RESPONSES TO COMMENTS

Stonestown Development Project

San Francisco Planning
Case No. **2021-012028ENV**
State Clearinghouse No. 2022040571

Date: April 24, 2024
Case No.: **2021-012028ENV**
Project Title: **Stonestown Development Project**
To: Members of the Planning Commission and Interested Parties
From: Lisa Gibson, Environmental Review Officer
Re: Attached Responses to Comments on Draft Environmental Impact Report for the Stonestown Development Project (Planning Department File No. 2021-012028ENV)

FIGURE 2-2
PROJECT SITE AND ADJACENT LAND USES (REVISED)

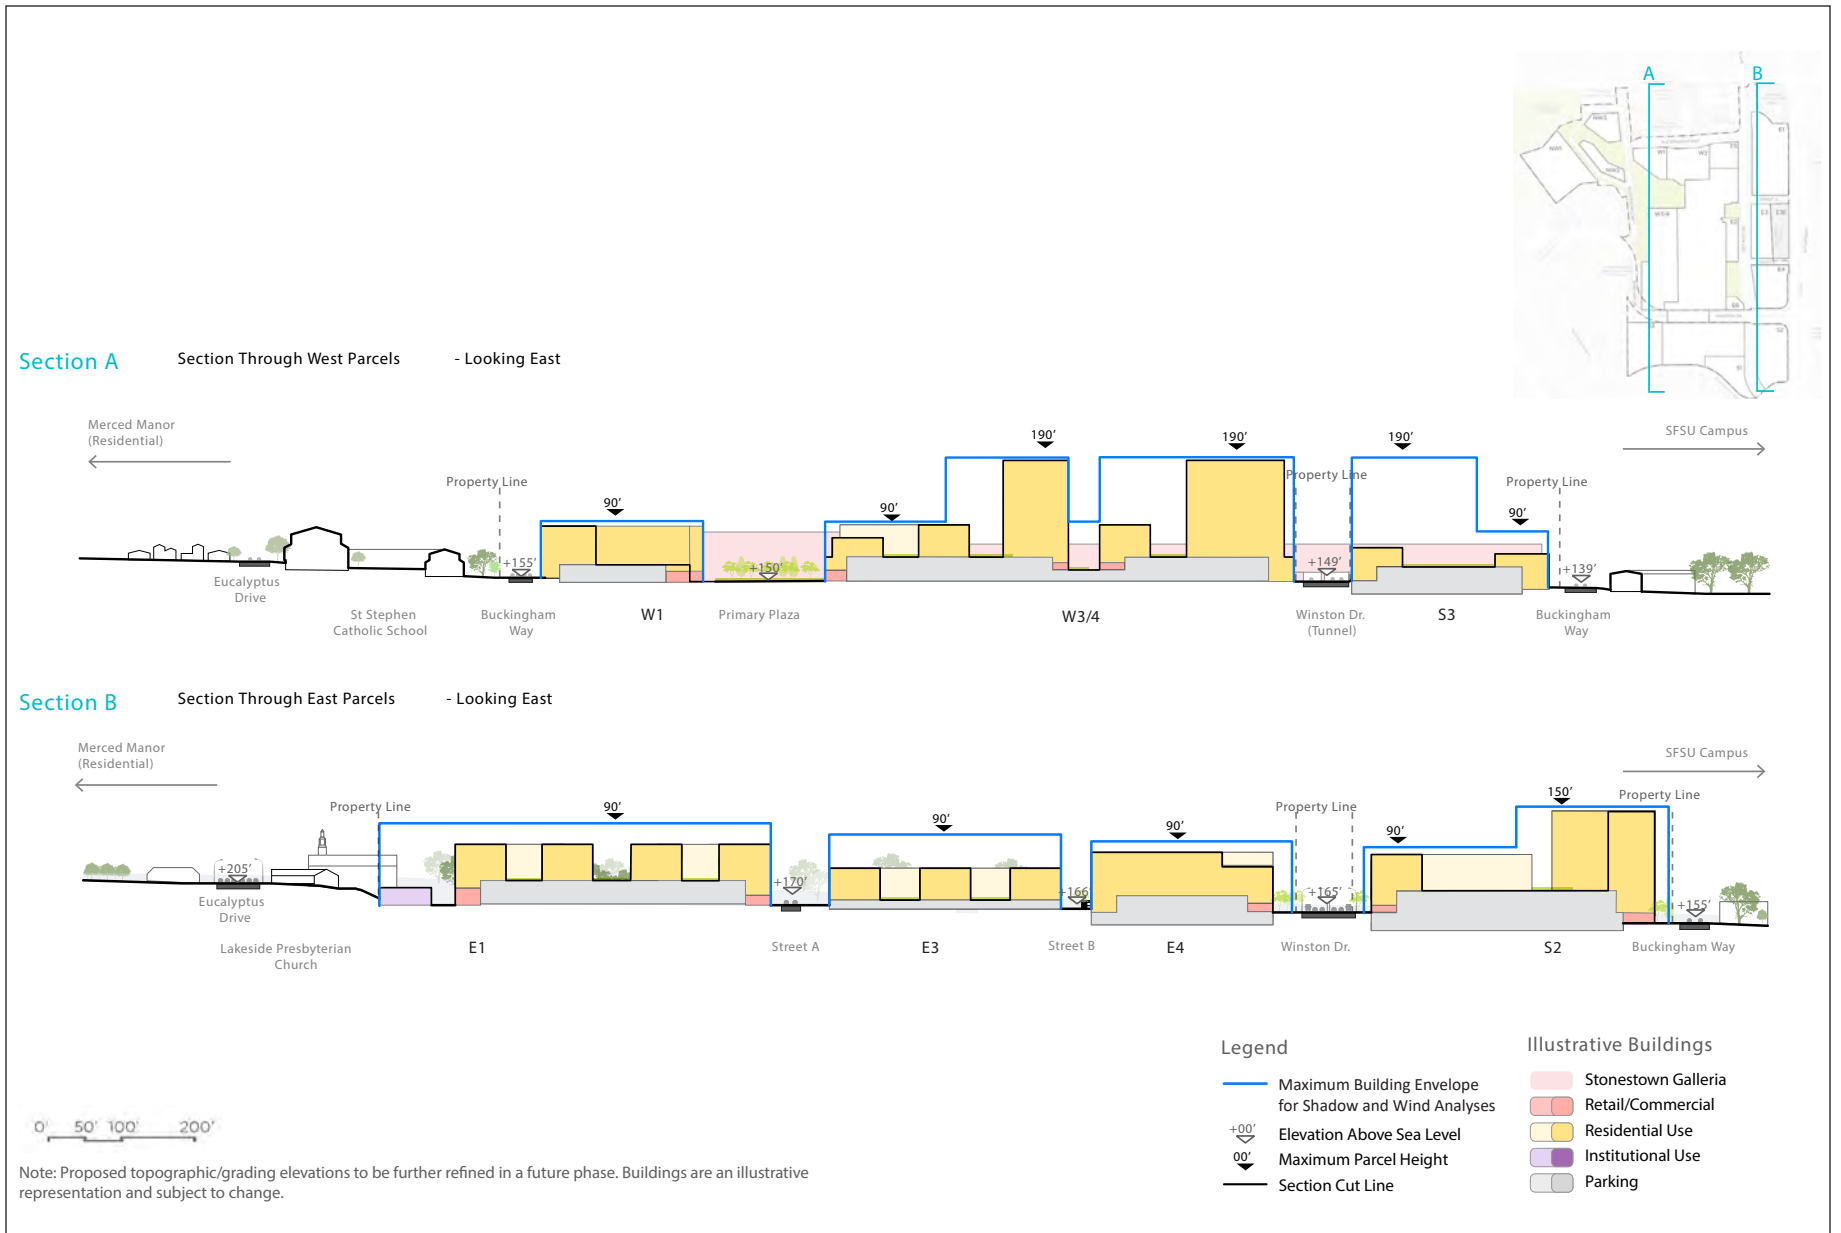
“Page 2-5, Figure 2-2. This figure showing the Project Site and Adjacent Land Uses is the same that was provided during the scoping process. I commented on that figure at the time and pointed out numerous errors in the figure. It was not updated or corrected. It is difficult to have confidence in the CEQA process when comments are not addressed and basic errors are not corrected.

Comments state that Figure 2-2 on draft EIR p. 2-5 contains errors pertaining to the land uses and has not been updated since the notice of preparation (NOP).

Figure 2-2 is intended to be a high-level general land use map indicating the primary uses in the area and does not necessarily correspond to the zoning designations. The existing zoning and height and bulk districts for the project site and immediate vicinity are presented in Figure 2-3, draft EIR p. 2-8. Regardless, Figure 2-2 (see p. 5-31) has been updated to address the comments.

FIGURE 2-7
PROPOSED SITE SECTIONS THROUGH WEST AND EAST PARCELS (REVISED)

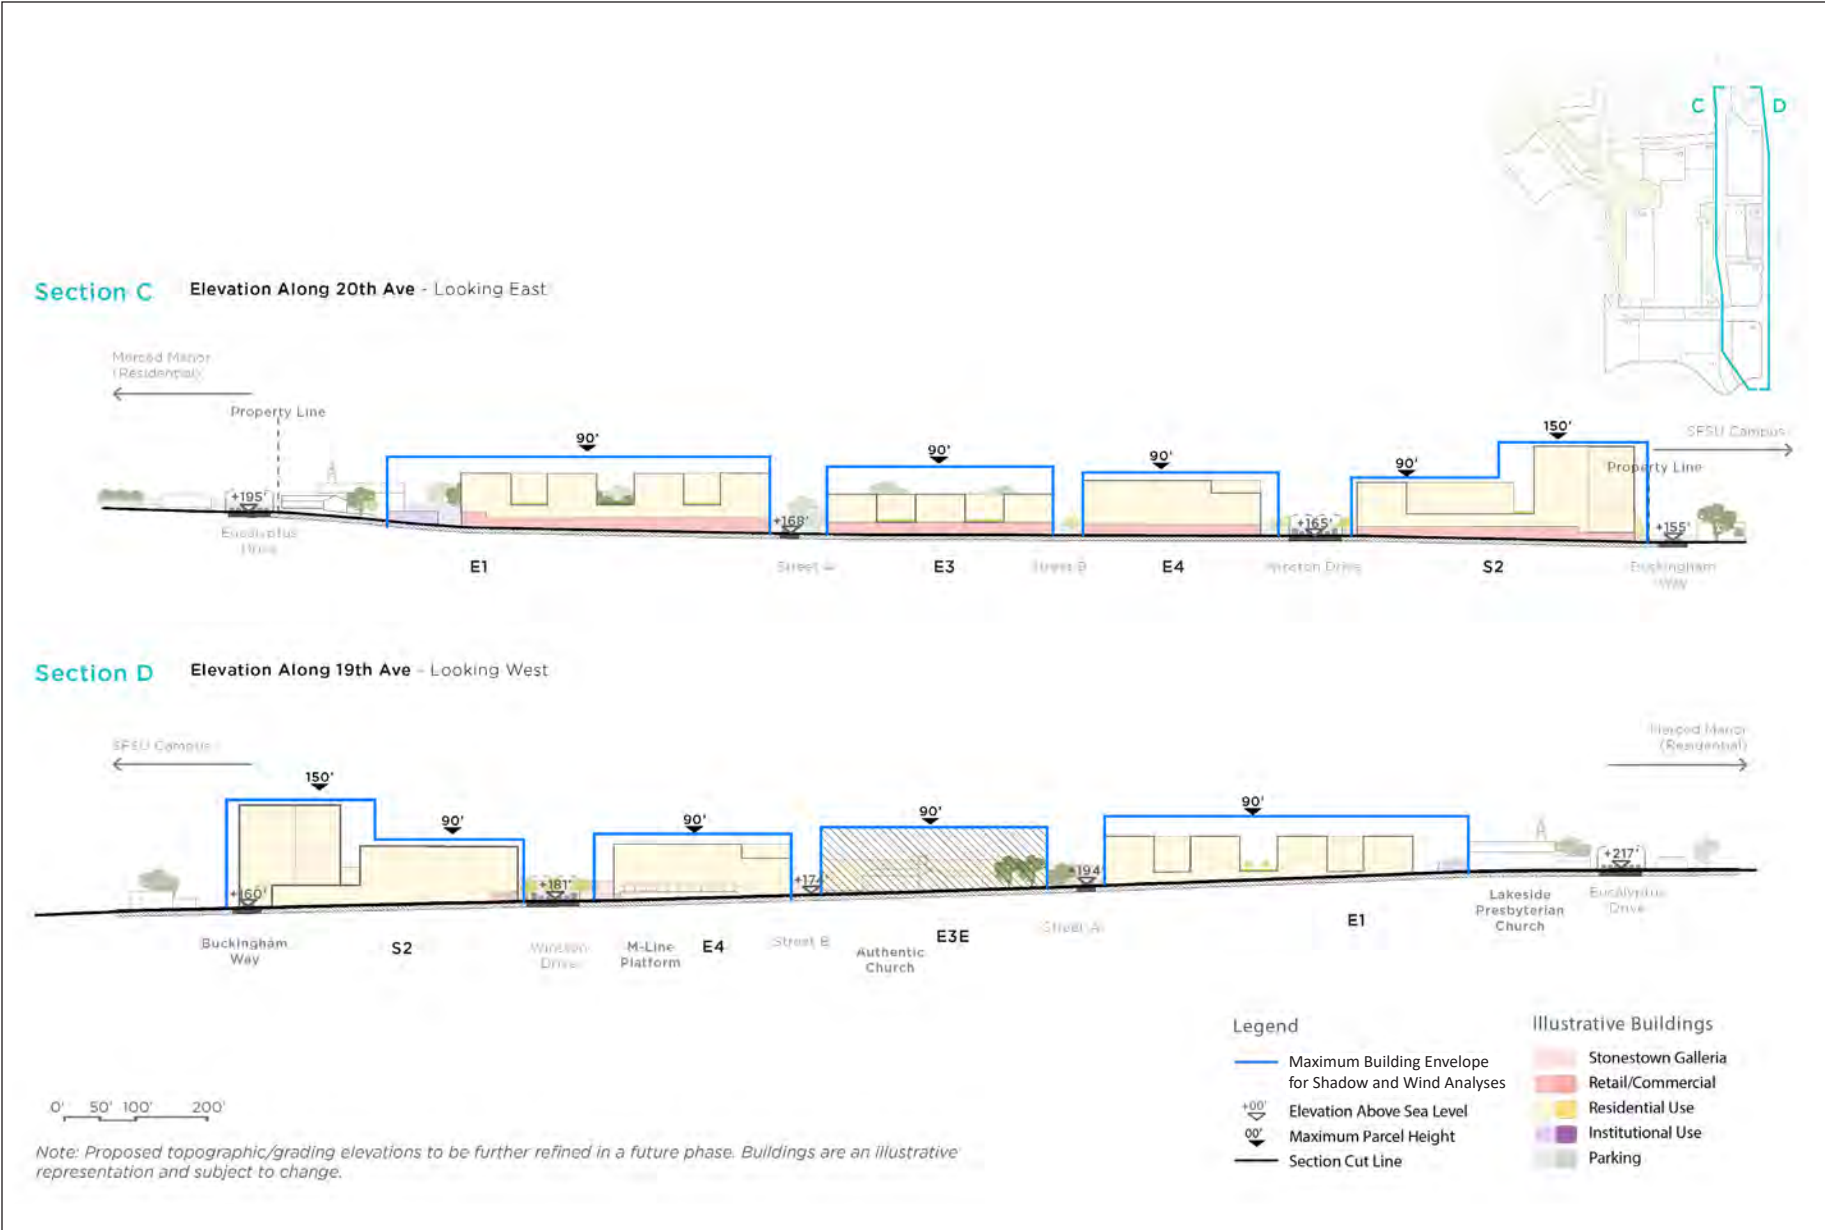
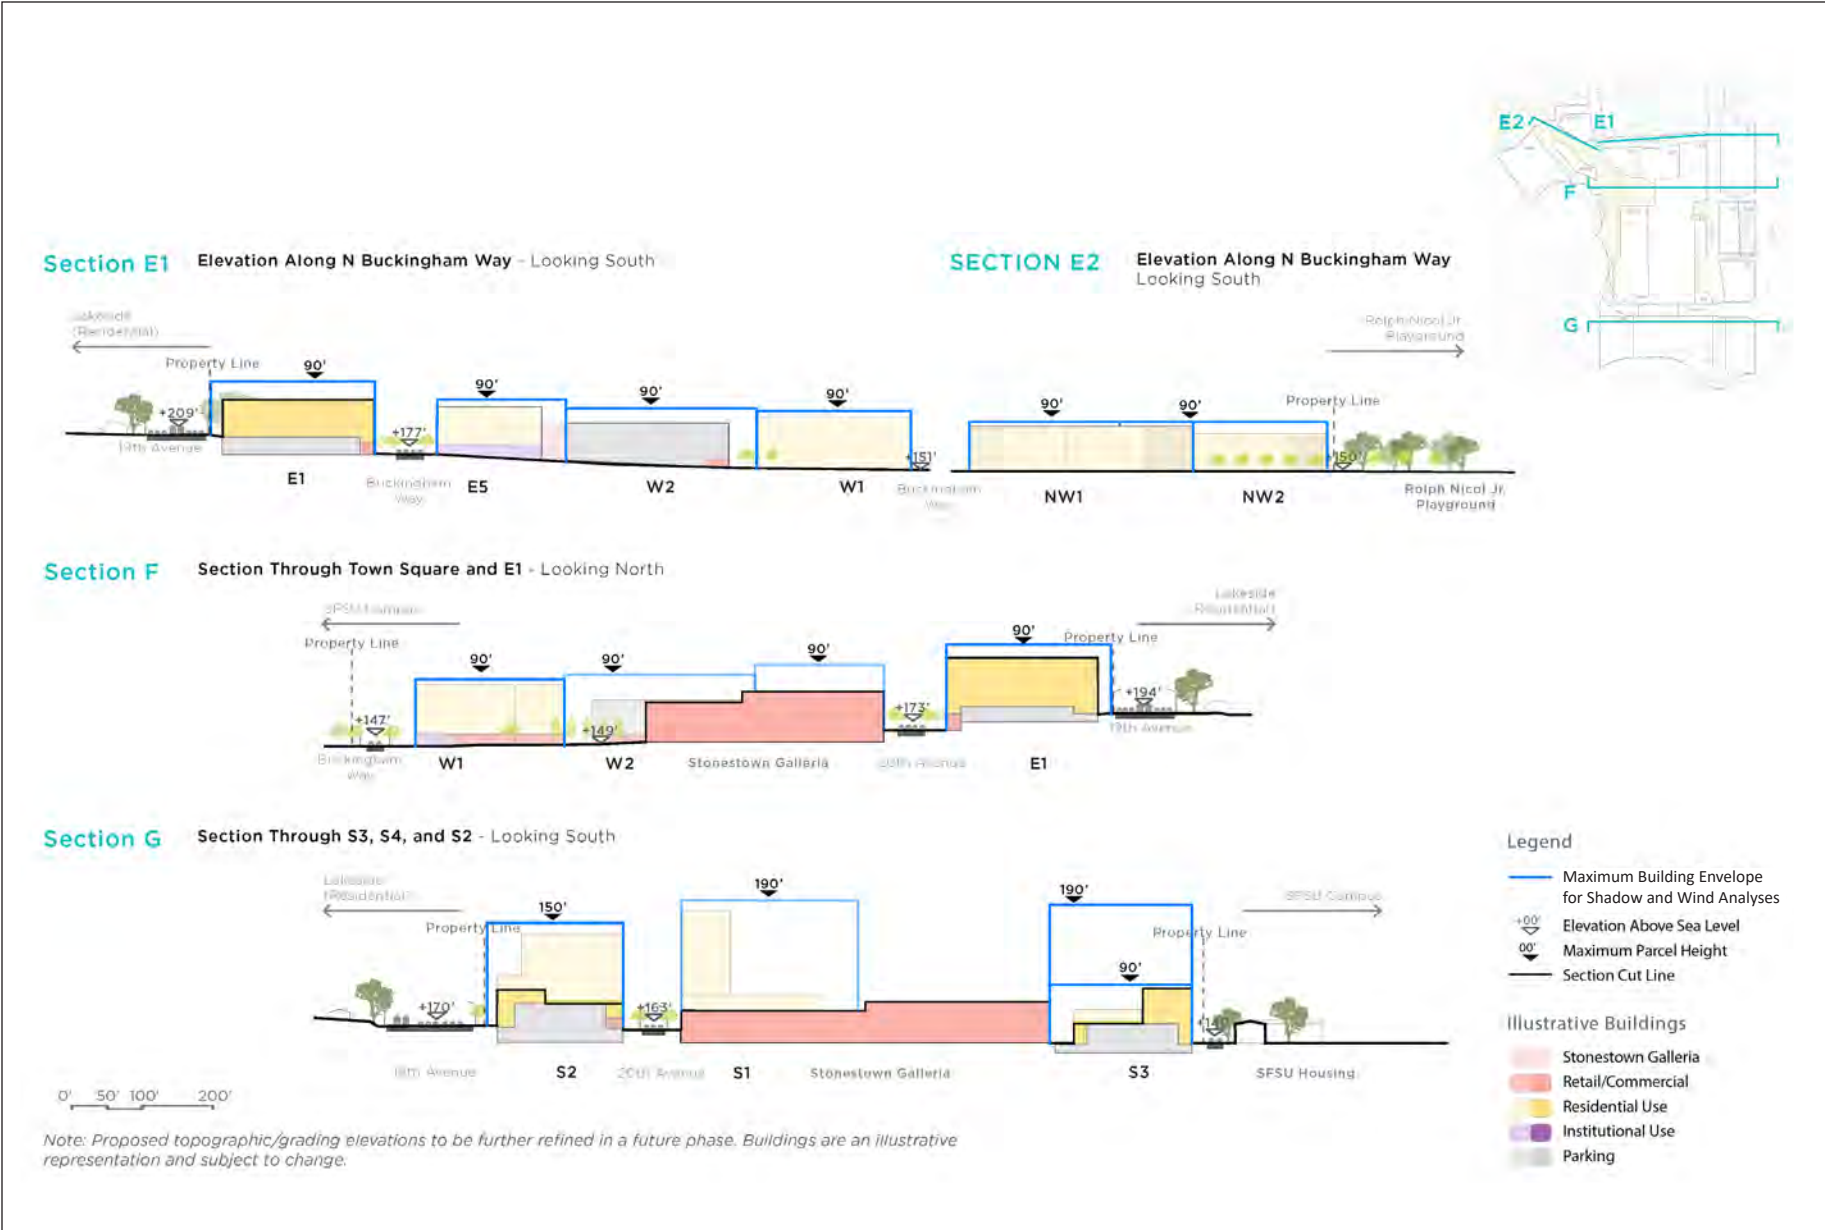
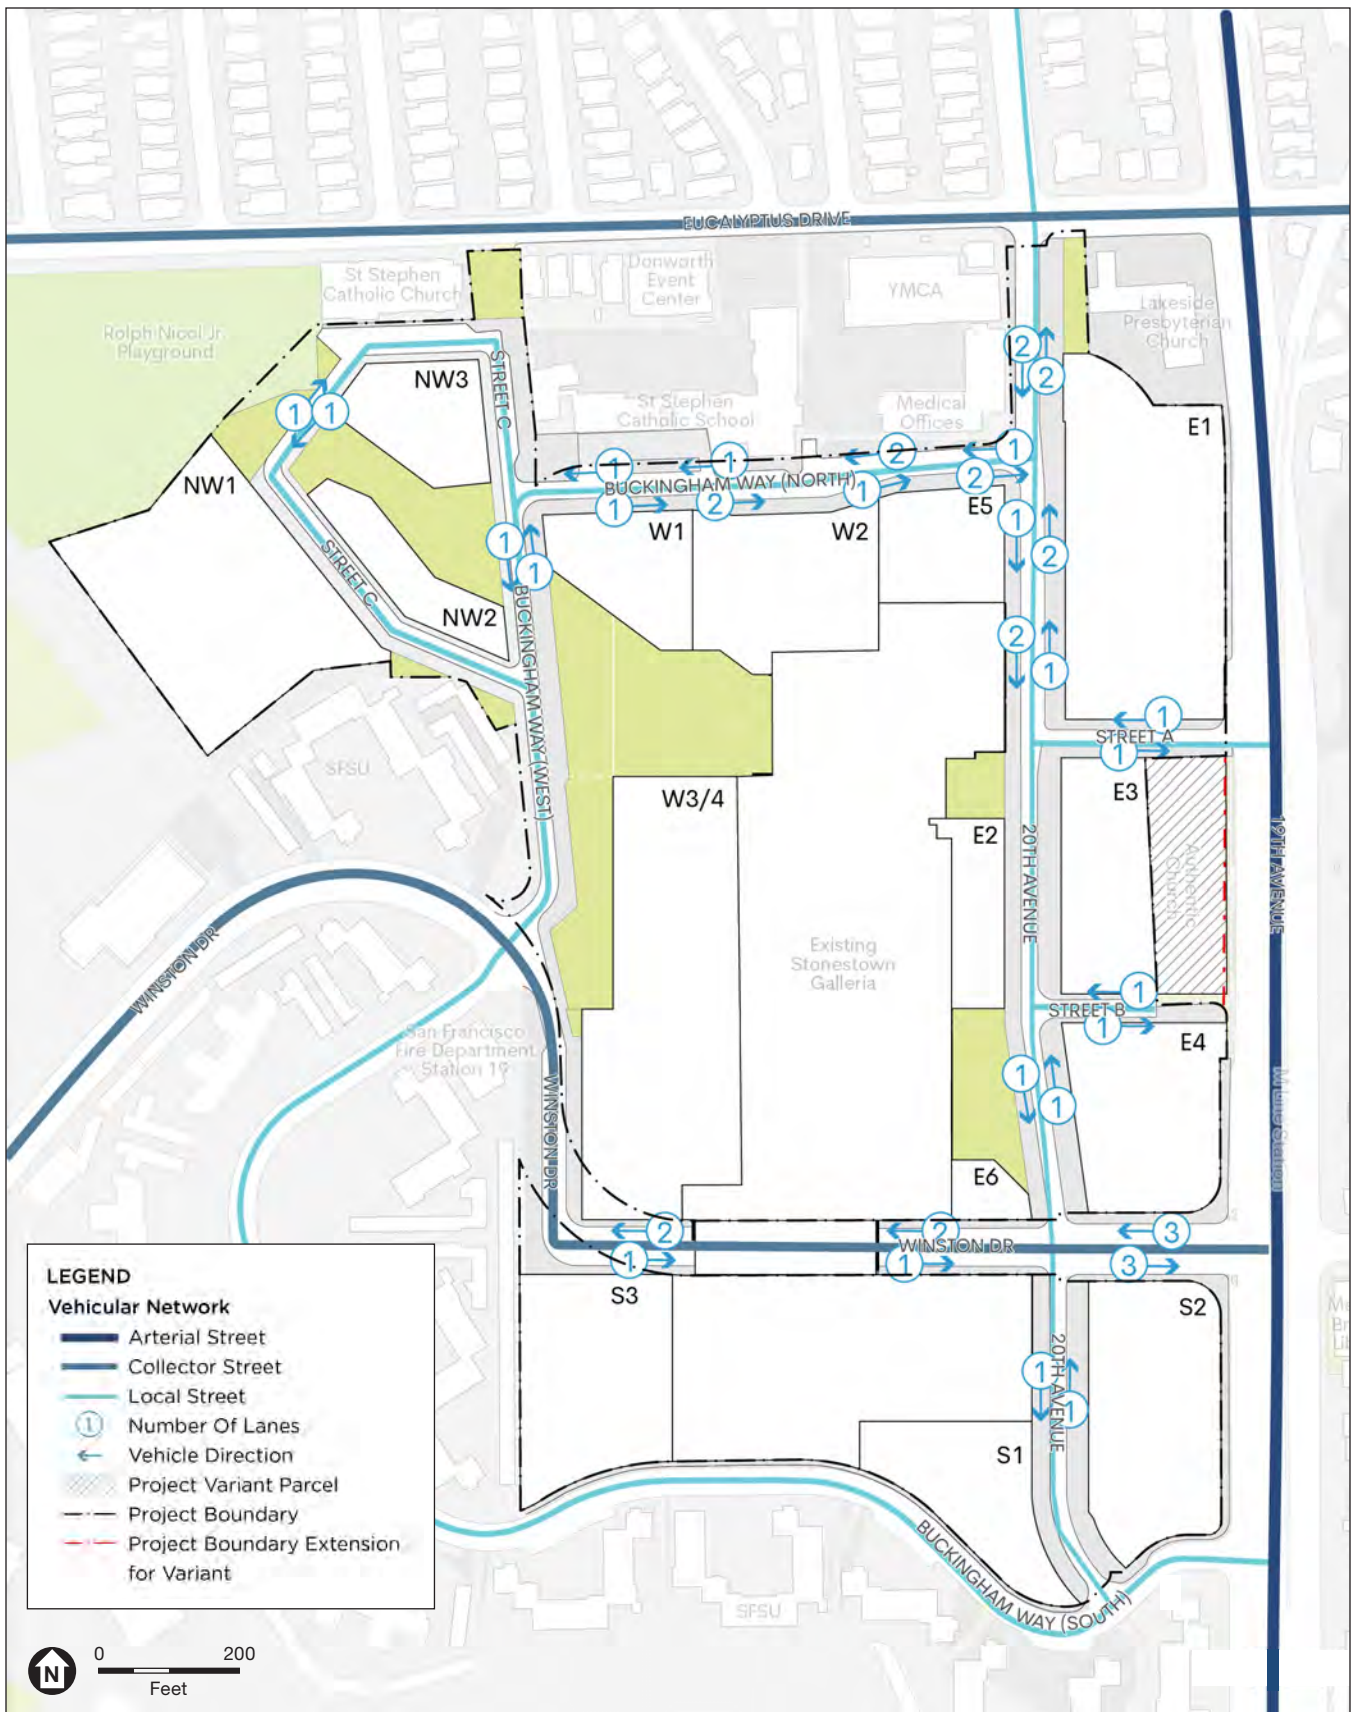
Page 2-15, Figure 2-7. The legend includes something called ‘CEQA Heights’. However, this term is not defined. Without such information, how is it possible to understand the importance of this term and what the blue line means?

In response to a comment, the “CEQA Heights” noted on Figures 2-7 to 2-9 on draft EIR pp. 2-15 to 2-17 refer to the maximum building envelopes evaluated in the EIR, specifically for the wind and shadow analyses. Figures 2-7 to 2-9 (see pp. 5-32 to 5-34) were revised to clarify the definition of “CEQA Heights.”
